City of
Richmond

Report to Development Permit Panel

Re: **Application by GBL Architects for a General Compliance Ruling at
6551 No. 3 Road**

That the attached plans involve changes to the design of the first phase of the CF Richmond Centre mixed-use development at 6551 No. 3 Road, incorporating voluntary artworks to screen above-grade parking and equipment, introduce Retail Tenant Storefronts Design Guidelines for tenant improvements and adjust surplus parking, are considered to be in General Compliance with Development Permit (DP 17-768248).

BUILDING 1A PARKADE ART ON PARK ROAD

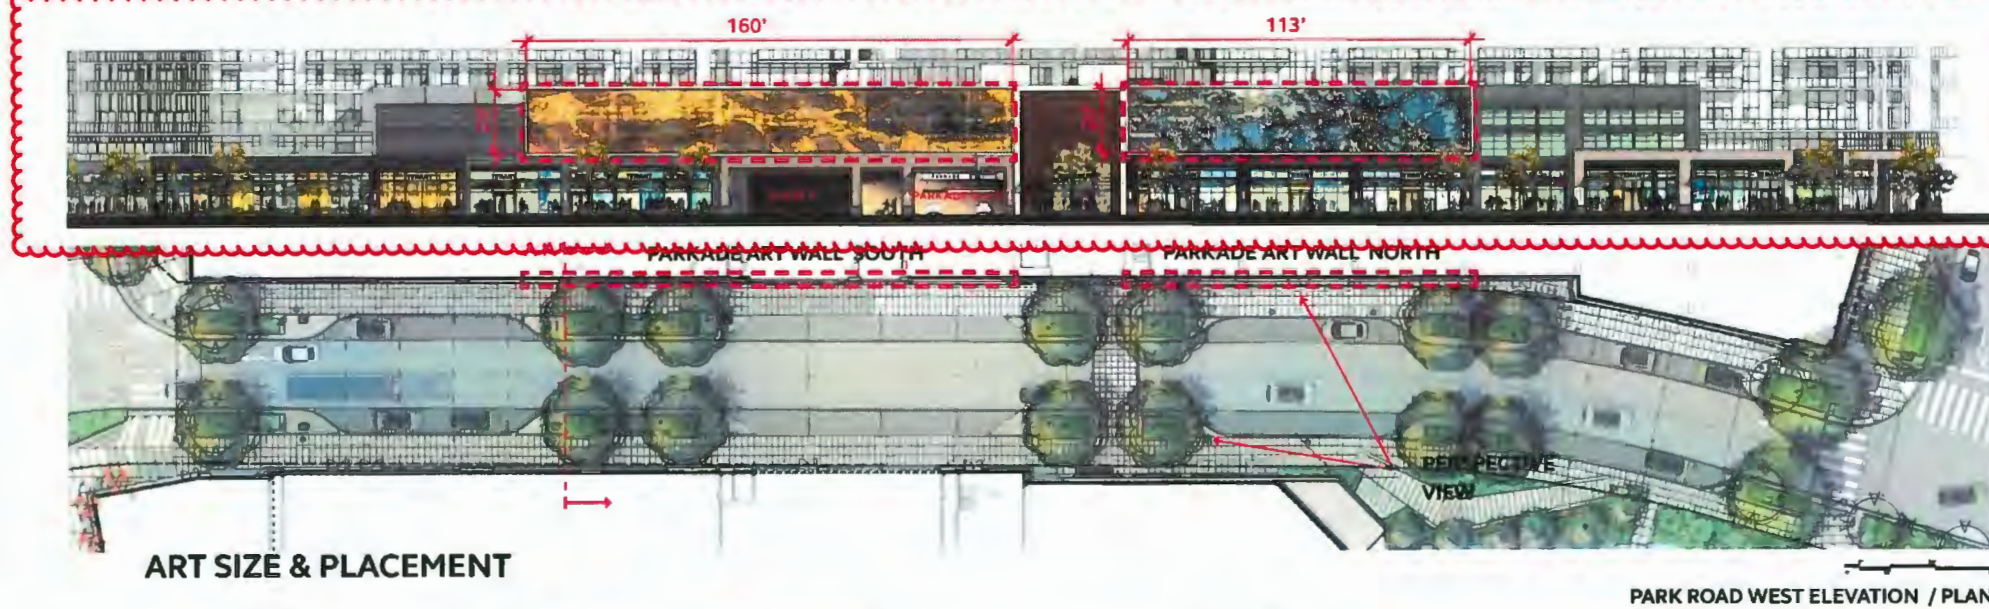
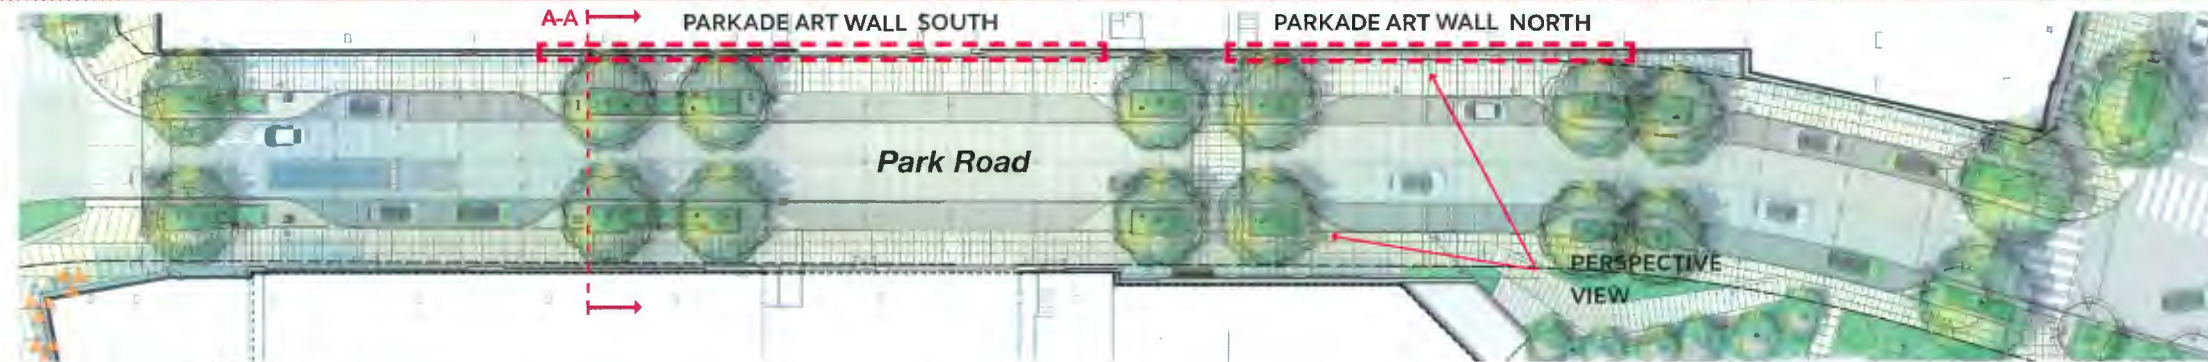
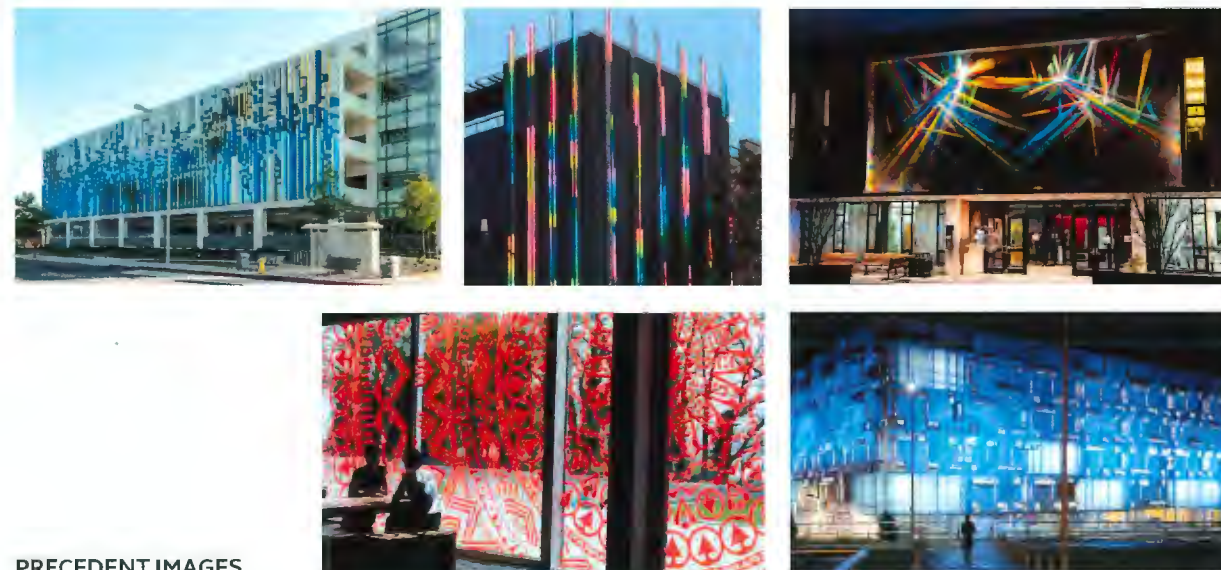
The subject additional artworks are proposed for installation on buildings fronting Park Road, north of Minoru Gate and include along the:

1. West side of Park Road: A three-dimensional mural by Rebecca Bayer screening parking at the second and third storeys of a mixed-use, high-rise building. This mural is called Overview. This is a large-scale sculptural artwork that represents the winding path of both the North Arm and South Arm of the Fraser River. As the viewer navigates the streetscape their perspective on the inverted topography of the river's landscape changes, revealing an arrayed vista above. The artwork engages the viewer by offering multiple perspectives.

It should be noted that minor changes are being proposed to the approved building façades to accommodate the proposed artworks, including louvers added and glazing removed from parkade openings to conceal mechanical equipment and better relate to public art mural louvers across Park Road. A portion of the building, at the break between the new Park Plaza entrance and the mall retail units along Park Road, glazing has been reduced in an effort to emphasize building separation.

ART PLAN - BUILDING 1C
SCREENING

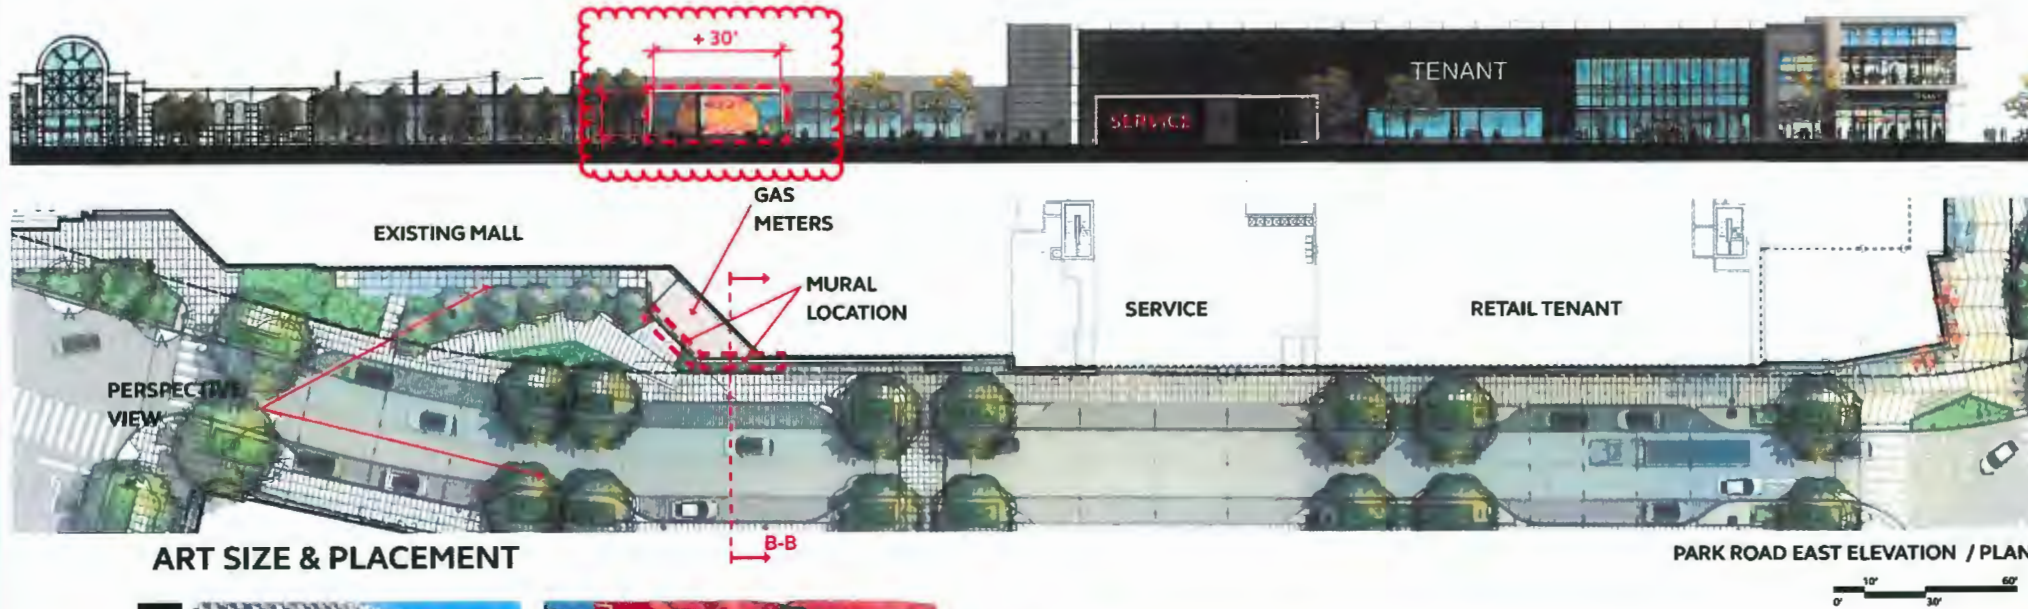
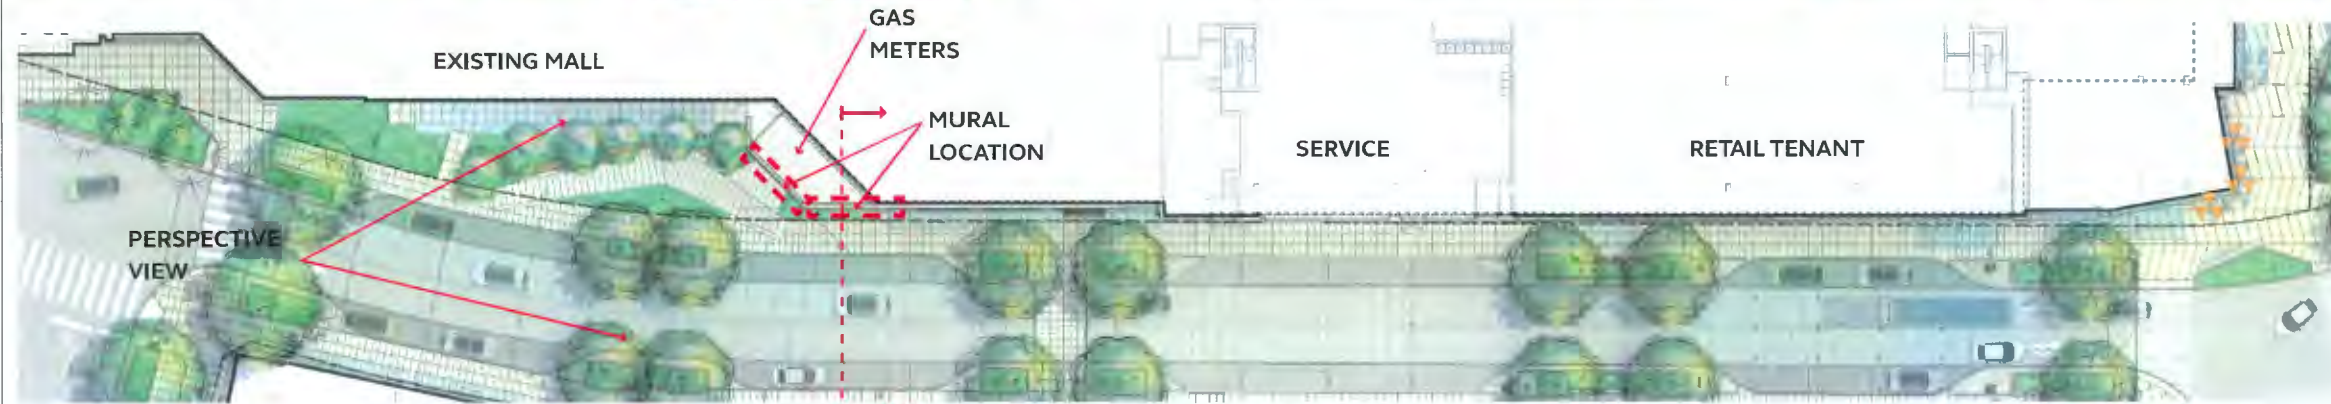
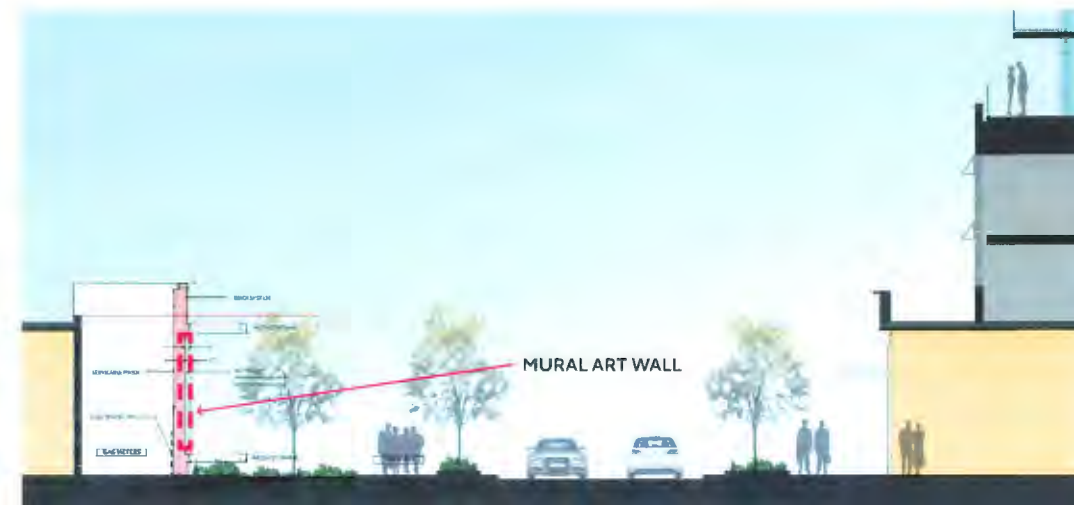
2. East side of Park Road: A painted mural by Kelly Cannell screening mechanical equipment (i.e. gas meter) at the ground floor of the existing shopping mall. This Indigenous mural features stylized eyes and fish against a geometric background. The central panels showcase large, detailed eyes surrounded by smaller fish motifs in shades of blue and gray. The surrounding panels have abstract triangular shapes in warm colours like yellow, orange and red. The vibrant colour palette and contrasting elements make this public art visually captivating.
